<i>Project Name:</i>	Rivergate Subdivision
<i>Proponent/Owner:</i>	Ben Steele / Rivergate LLC
<i>Project Address:</i>	Approximately 1900 West 600 South
<i>Request:</i>	109 Lot Subdivision
<i>Current Zoning:</i>	NR-6
<i>Date of Hearing:</i>	Dec 15 th 2022
<i>Type of Action:</i>	Quasi-Judicial
<i>Submitted By:</i>	Russ Holley, Senior Planner

Staff recommends that the Planning Commission **approve** a Subdivision Permit for project PC 22-066 Rivergate Subdivision, located on approximately 30.54 acres at approximately 1900 West 600 South; TIN #02-076-0002; -0008.

Rivergate Preliminary Plat Application
November 3, 2022

RIVERGATE SUBDIVISION
PRELIMINARY PLAT

ROW
CROSS-
SECTIONS

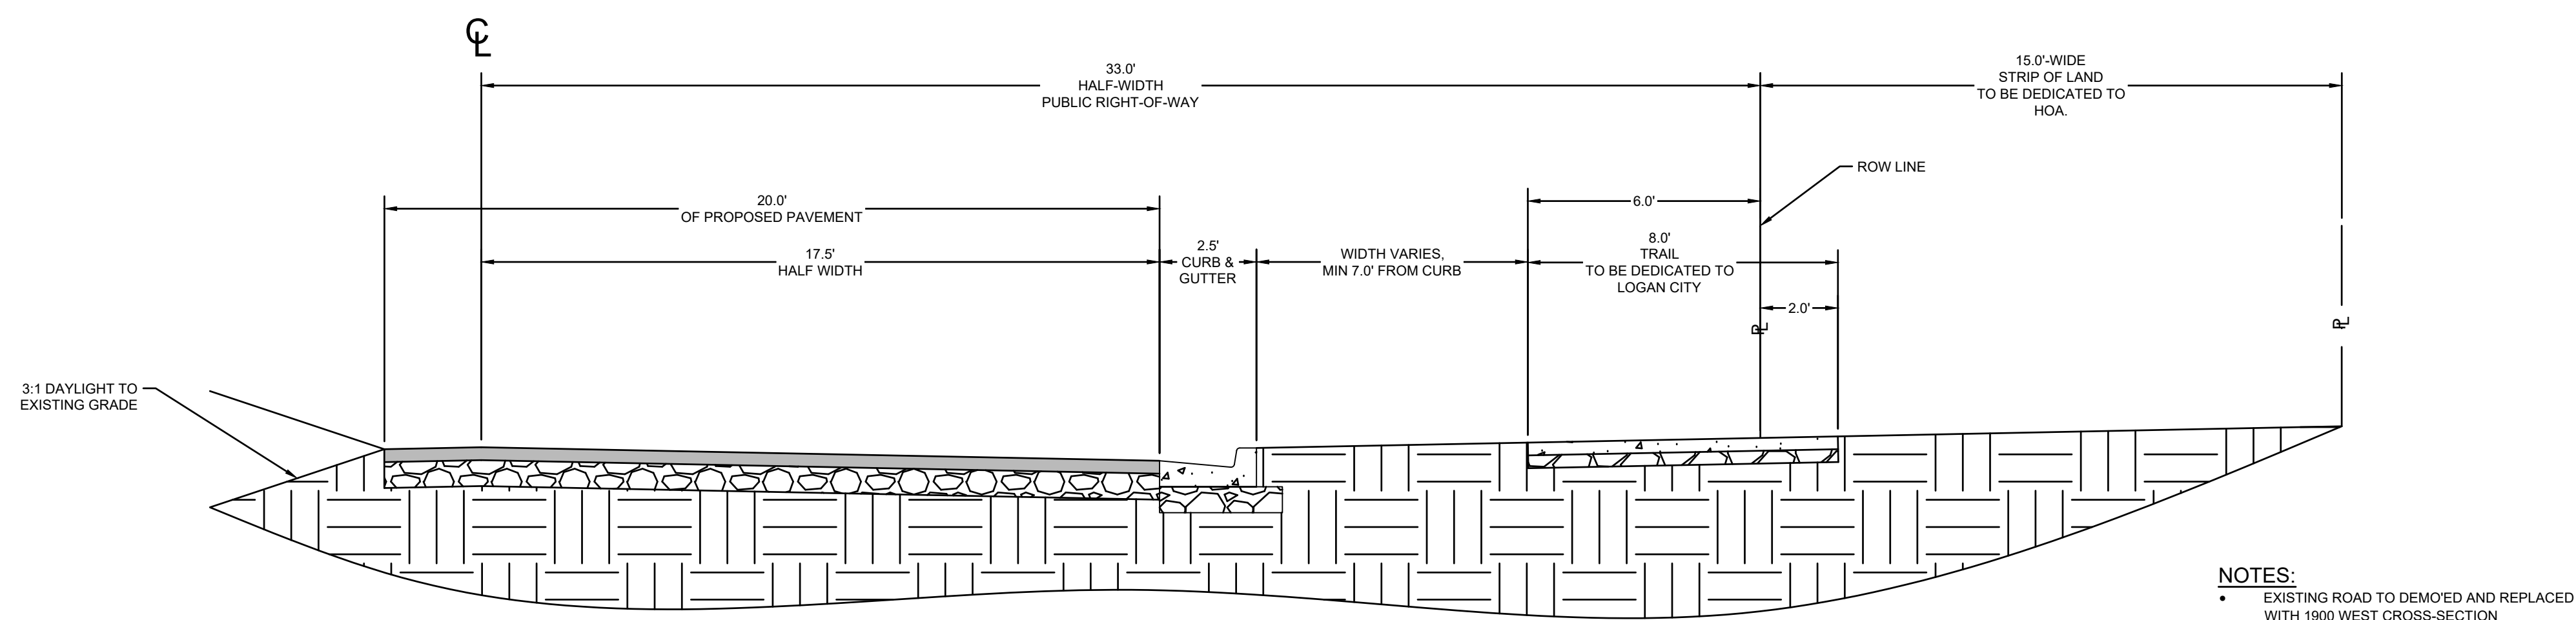
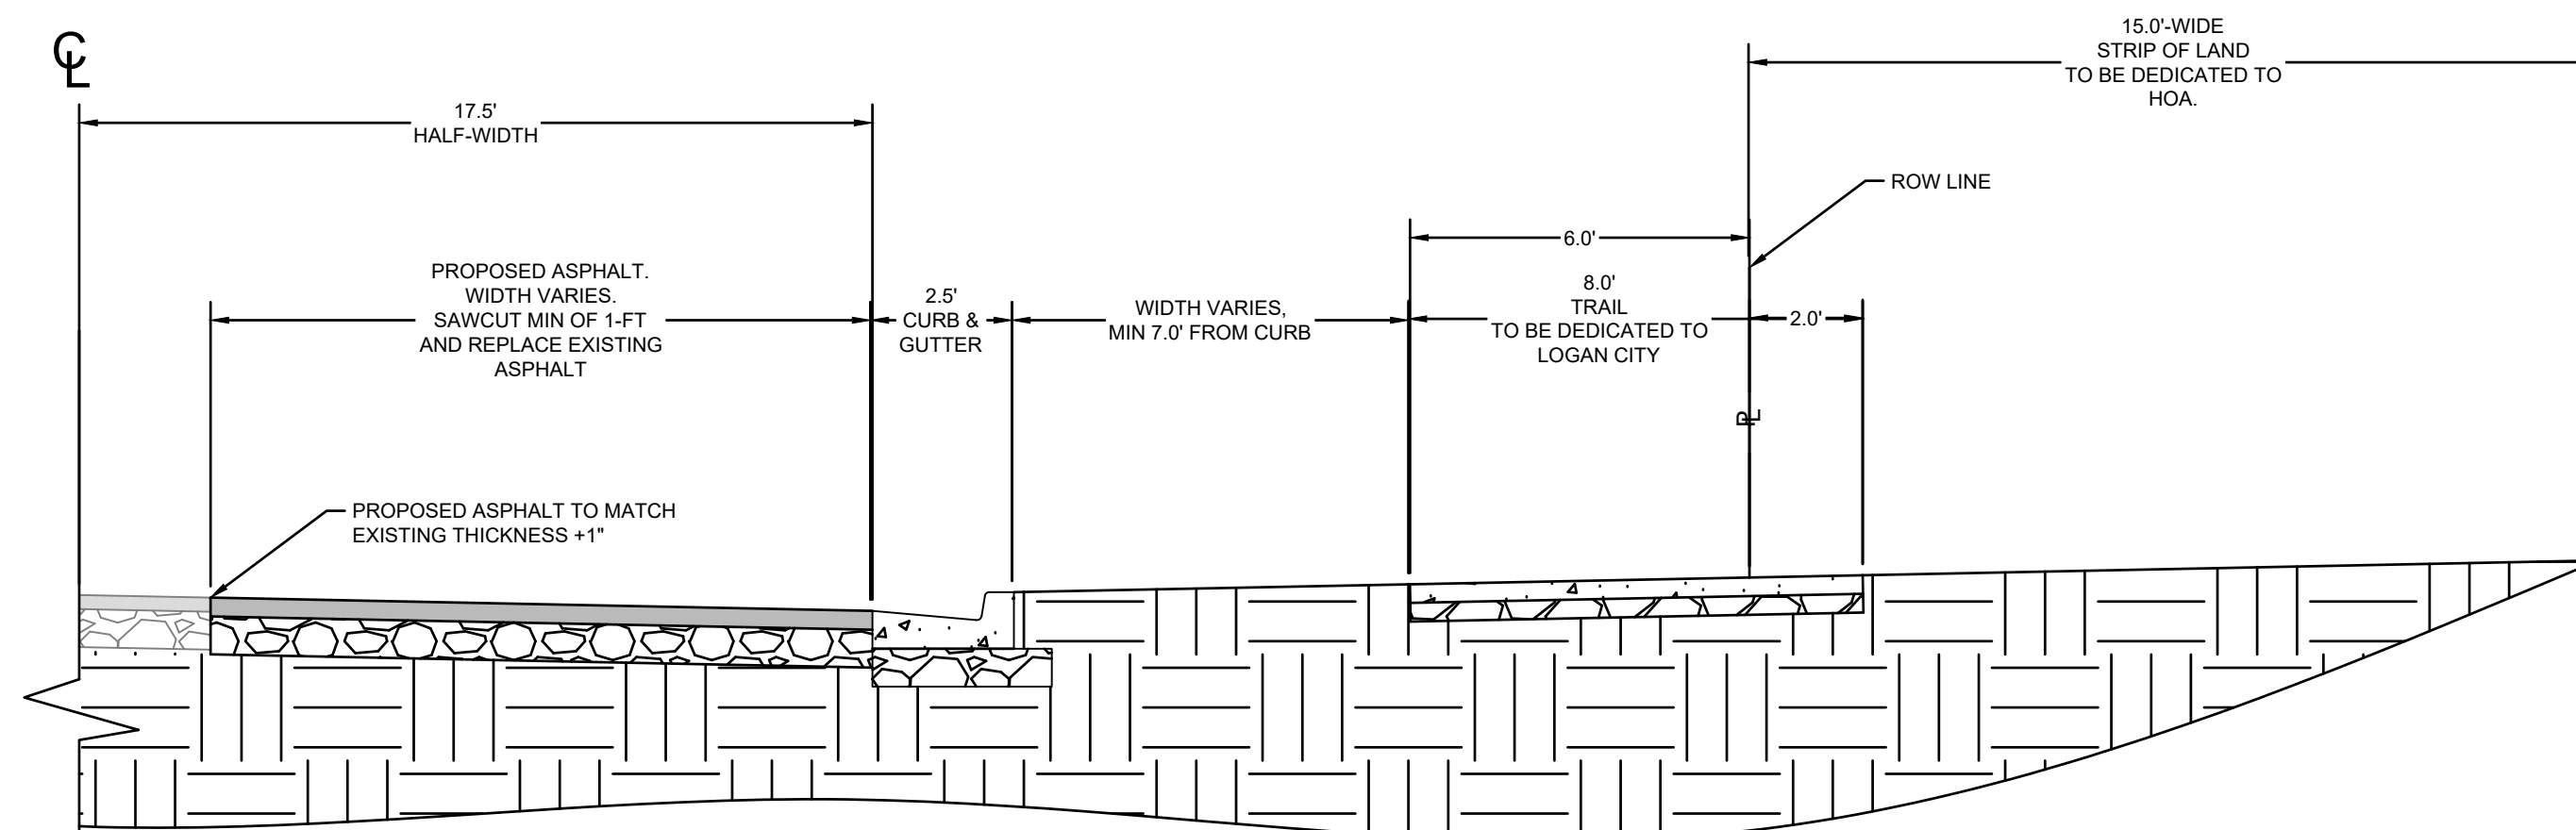
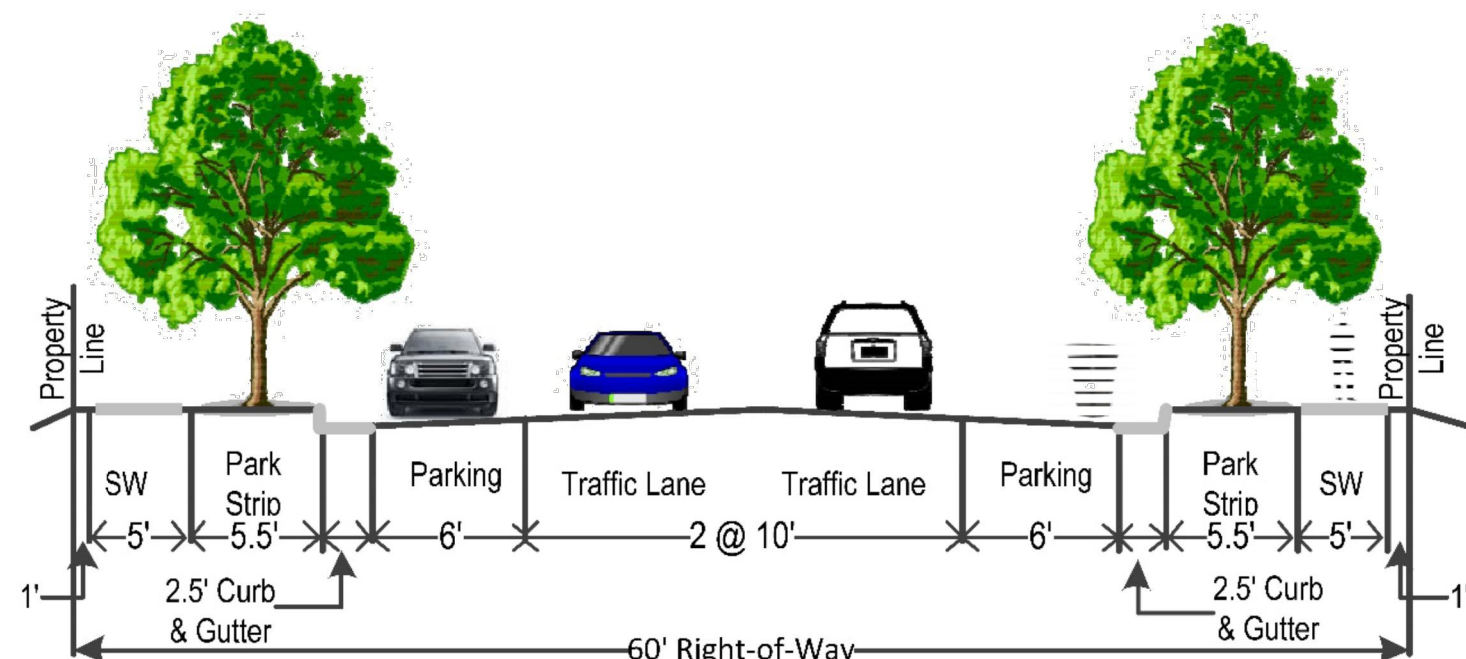
22. 600 West is identified as a major arterial on the City's transportation master plan and as such requires a 102' right of way. Dedicate sufficient property to achieve a total 83' of right of way. Preserve an additional 13' of right of way for future roadway improvements and acquisition. Prepare construction plans to build a total pavement width of 48' (5, 12, 14, 12, 5) including curb, gutter, sidewalk, parkstrip.

23. 1900 W is designated as a gridded street and as such shall be designed and constructed to Logan City's gridded street standards.
 24. 575 S shall remain a minimum 125' from the 600 S / 1900 W intersection as measured from nearest edges.

25. Pavement cross-sections of all roads shall meet the minimum standards for a minor arterial, collector, and local roads per Logan City Design Standards.
